**75 LAWN ROAD, LONDON  
NW3 2XB**

**BASEMENT IMPACT ASSESSMENT ADDENDUM  
MAY 2019**

**Figure 1: Ground Movement Assessment Wall Location Plan**  
(with Alan Baxter Report text added in red)

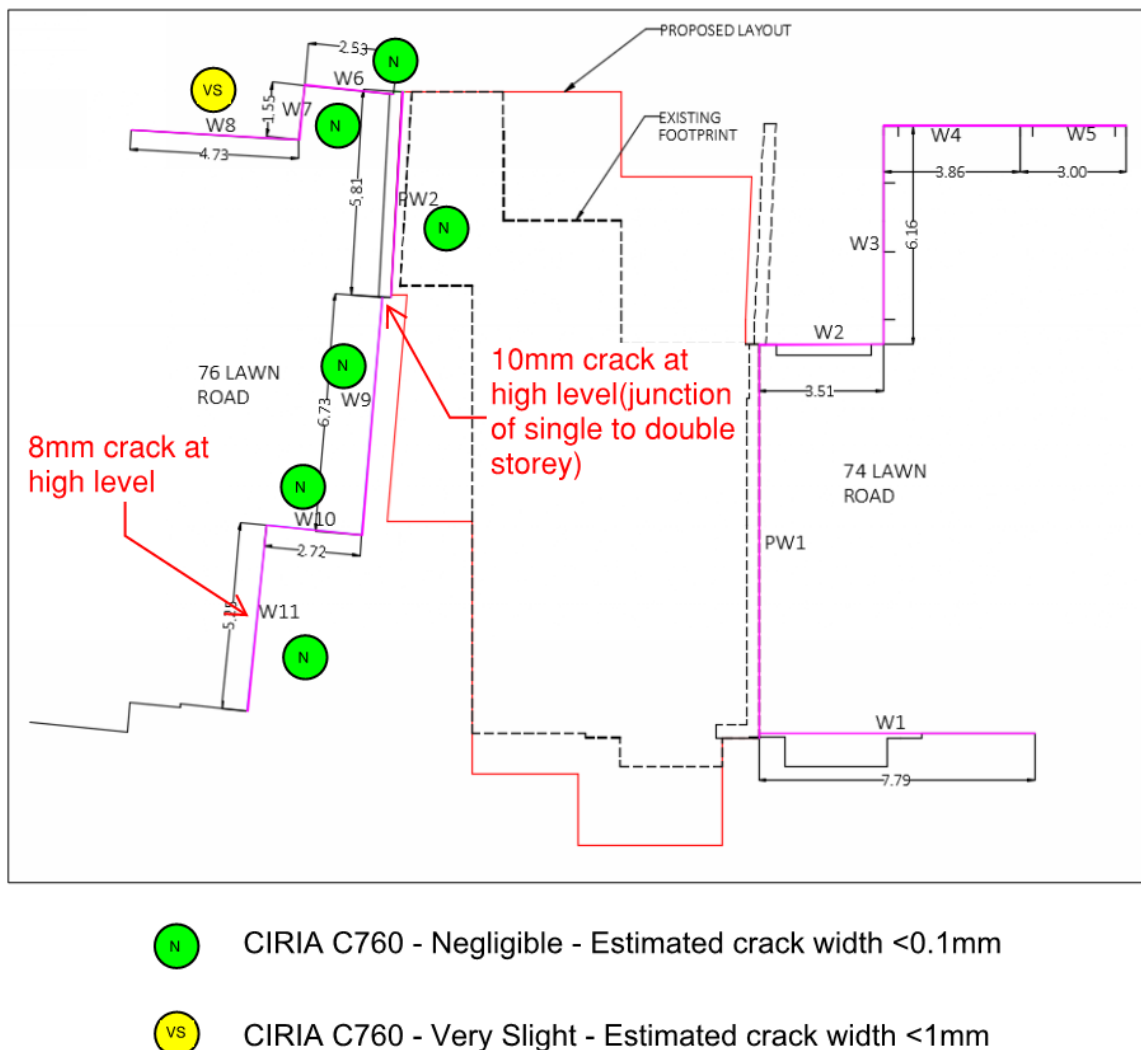
Figure 1 has the cracks within the proximity of the works identified in the Alan Baxter Report added for information. This shows that one wall, W11, now has an existing crack that may be subject to additional movement due to the basement works. The predicted movement is however negligible i.e. less than 0.1mm. The crack at the junction of the two-storey attached section of the buildings is not considered as part of the analysis is as it is at the junction of what appears to be two different walls (W9 and PW2).

**Figure 2: Proposed location of structural enabling works**

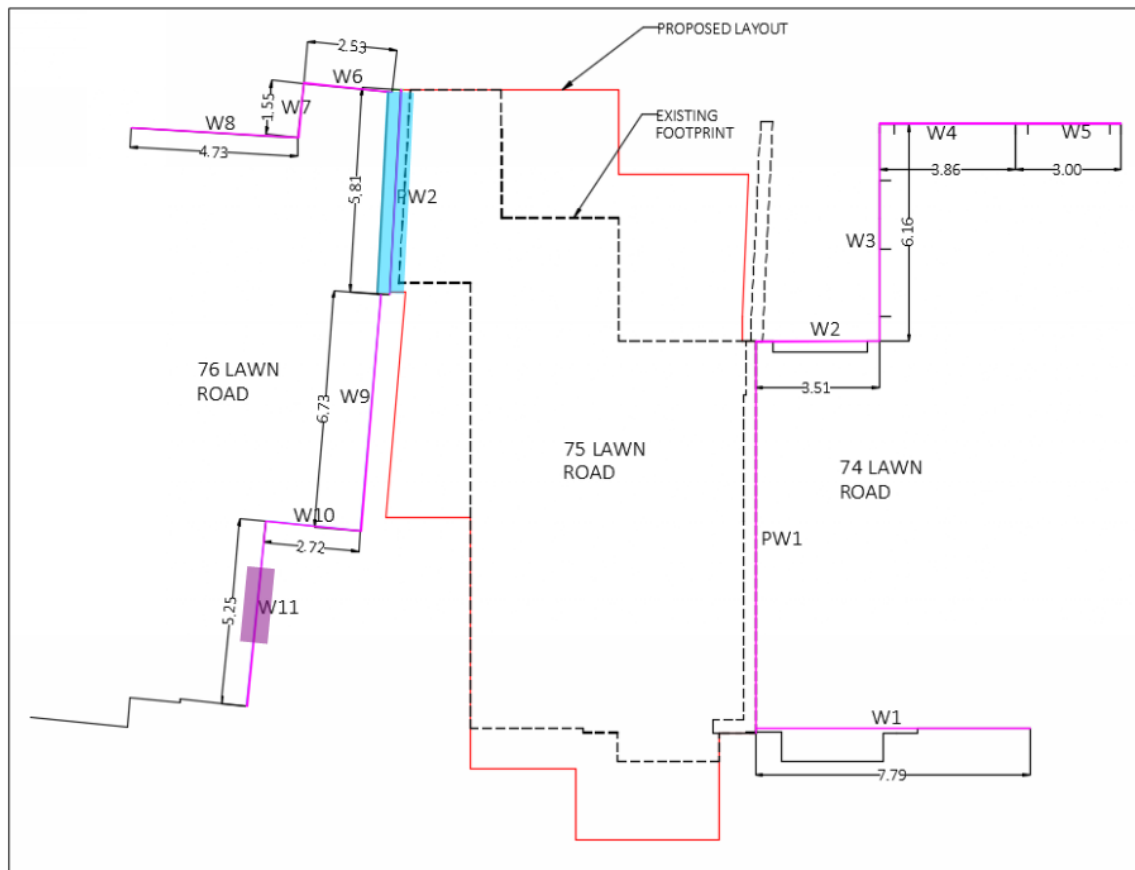
Based on the damage analysis above we believe the proposed basement at No 75 can be constructed without risk to the structural stability of No 76. However, at Camden's request, this addendum offers to undertake additional mitigation measures prior to work commencing to ensure predicted movements will be in line with the original ground movement modelling. As such we propose the following changes to the initial construction sequence:

- Helifix repair to W11 of No 76 (horizontal steel reinforcement bars inserted into existing wall)
- Underpin the assumed party wall (refer to Figure 2)
- Following this the sequence will remain as given in the BIA.

- Extent of underpinning to assumed party wall between 75 and 76
- Proposed location of Helifix repairs repairs to W11 (No 76)
